CITY OF WESTFIELD, IN
Advisory Planning Commission Meeting Agenda_06_07_2021

BOARD OR COMMISSION: Advisory Plan Commission (APC)

MEETING DATE: Monday, June 07, 2021 at 07:00 PM

Figure 1
Parcels circa 2006

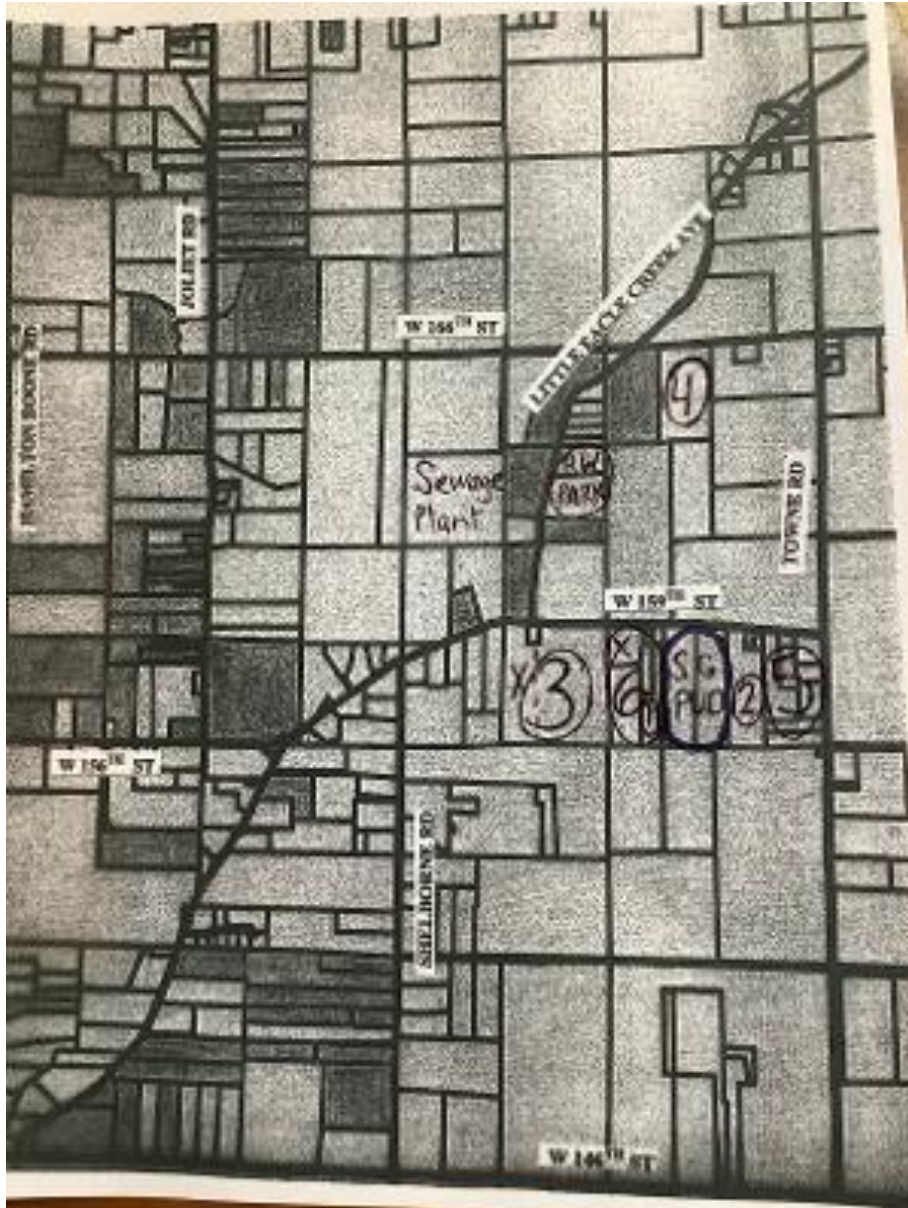
- Sycamore Glen SG PUD is circled.
- Multiple small acre farms, unlikely to change
- Equestrian properties are shaded darker.
- X's mark new equestrian, cattle, chicken farms near proposed SG PUD.
- Predates Bent Tree & Del Webb., or the multitude of new 5-20 acre AGSF1 small parcels that have been added.

Future parcel requests for high density rezones in the SW quad are likely to look a lot like Sycamore Glenn in Figure 1. Modest acreage of 20-50 acres embedded among small ag parcels. That is why it is important to consider the competing land use of a high density subdivision in the midst of small ag parcels. ***It is not how the adjacent current small ag parcels look today, it is presevering the right for that property to use any allowed AGSF1 use for ag in the future.*** In the area immediately to the east of SG PUD, marked with a 5 on Figure 1, there are 9 small AGSF1 parcels of varying size. In the area immediately to the west of SG PUD. maked with a 6 in Figure 1, there are 6 small AGSF1 parcels. One of those 6 parcels has cattle and chickens currently which is maked with an X in Figure 1.

Go back to figure 1 and look at the AGSF1 parcels located immediately east and west of SG PUD (marked with a 5 and 6 on Figure 1). The proposed trail for Sycamore Glenn is adjacent to 159th St. and runs east and west across the northern property line. There are 9 rural properties to the East and 6 to the west of SG PUD. It is essentially a trail to nowhere. The small ag parcels are unlikely to develop and ever put in a trail. The Comprehensive Master Plan calls for pedestrian systems that link neighborhoods, improve connections between different residential areas and parks, schools, and commercial.

Demand is high. Homes with acreage and acreage without homes zoned Ag in the SW quad are highly sought after. Many people came and are coming to this part of WWT exactly because of the vision of the comp plan for the SW quad. They want to live the rural life. Finally, look at the two circles on Figure 1 labeled 3 and 4:

Previous Concept Plan

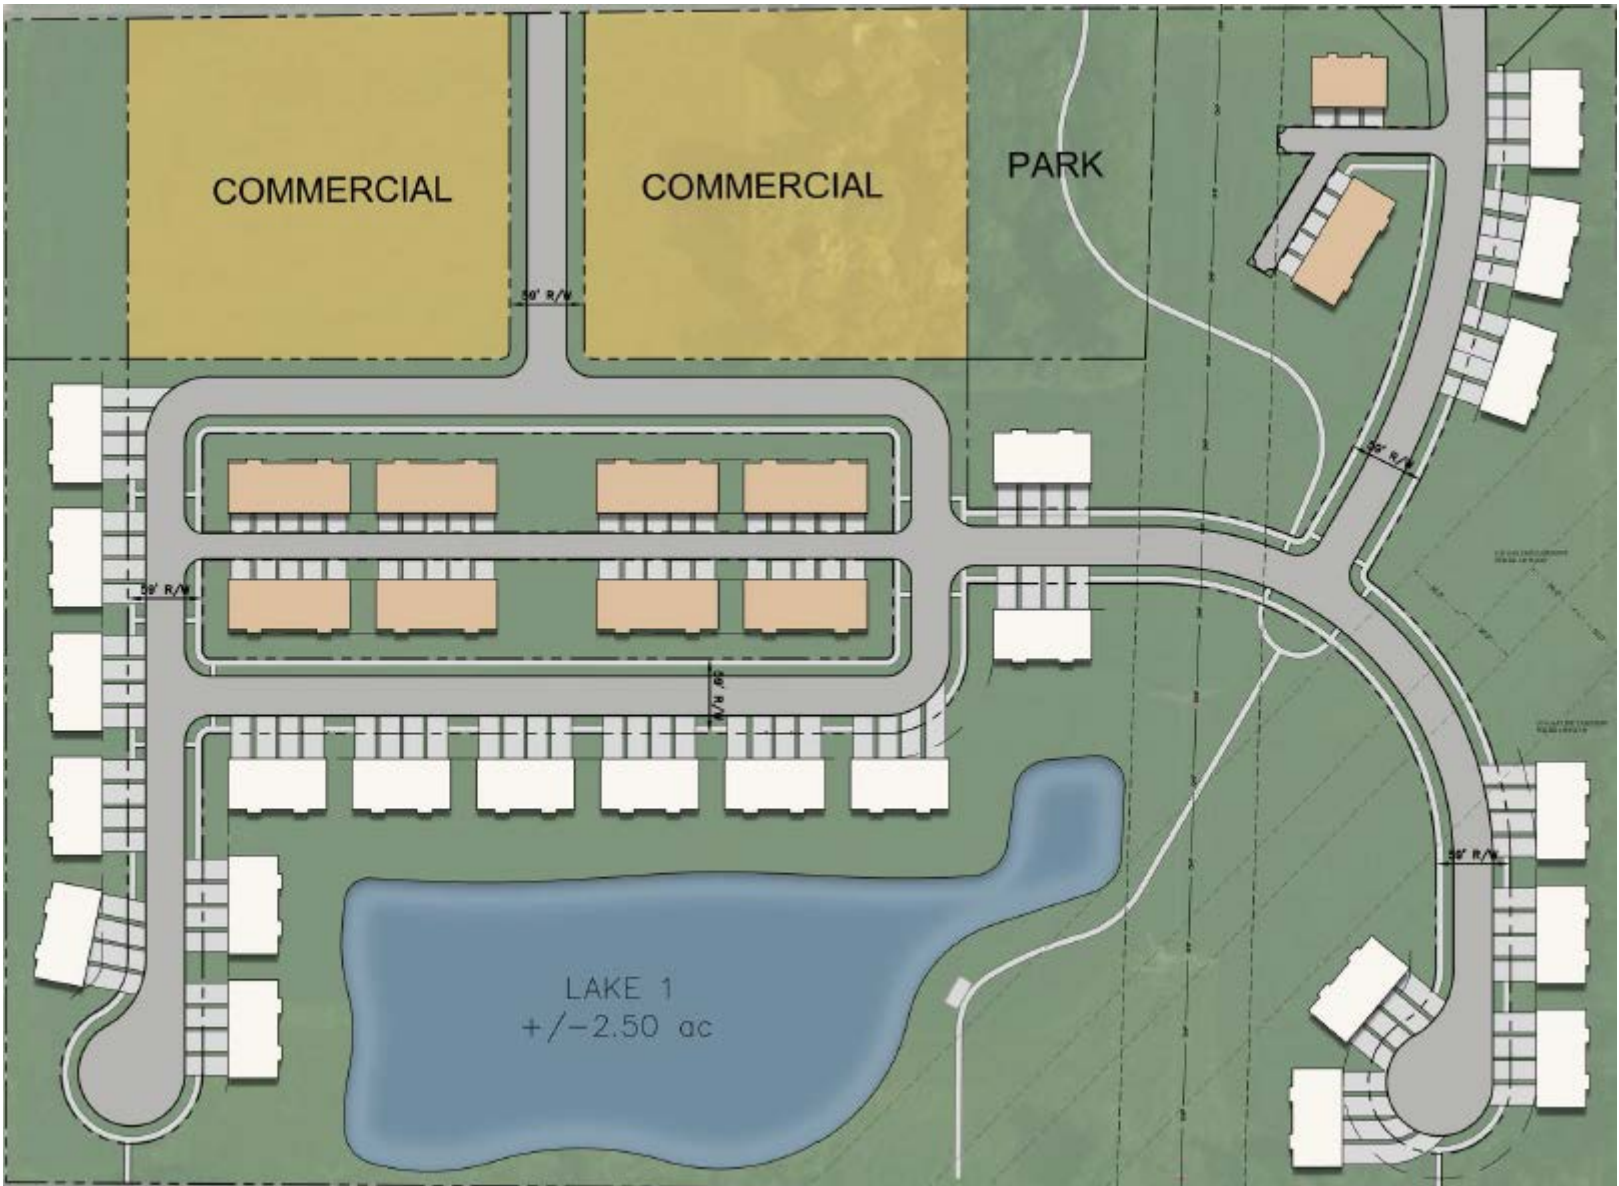
The Petitioner has made several changes to the proposed ordinance and exhibits since the April 5, 2021, Public Hearing. These changes can be seen in the Redlined Ordinance (see **Exhibit 11**) and Concept Plan Comparison (see **Exhibit 12**), and are discussed in the Updated Project Narrative (see **Exhibit 13**). Additionally, an Issue List was provided to the petitioner following the Public Hearing. A response to that list has been provided and it included as **Exhibit 14**.

Ackerson Farms Primary Plat and Overall Development Plan

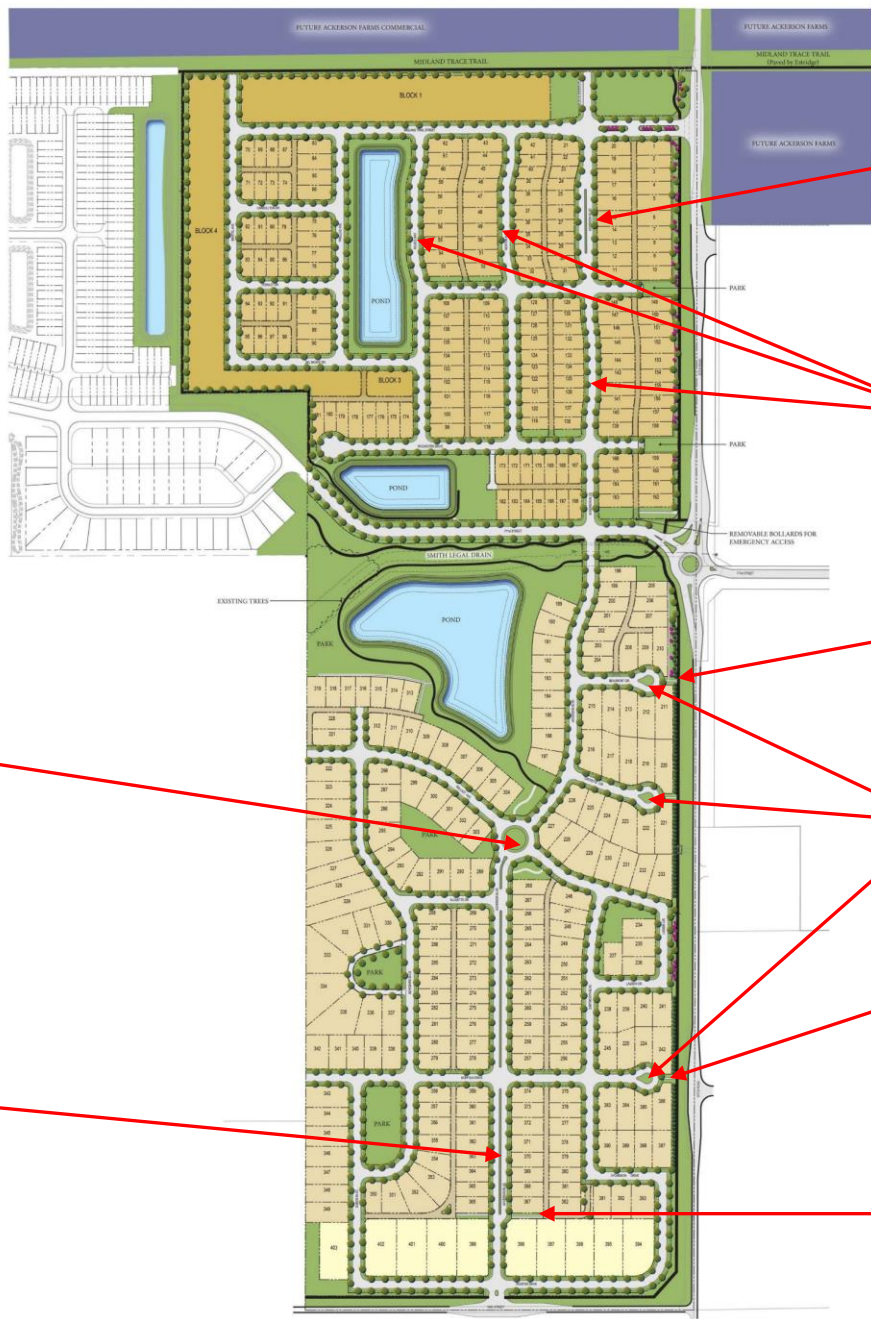
Created divided street with landscaped center median
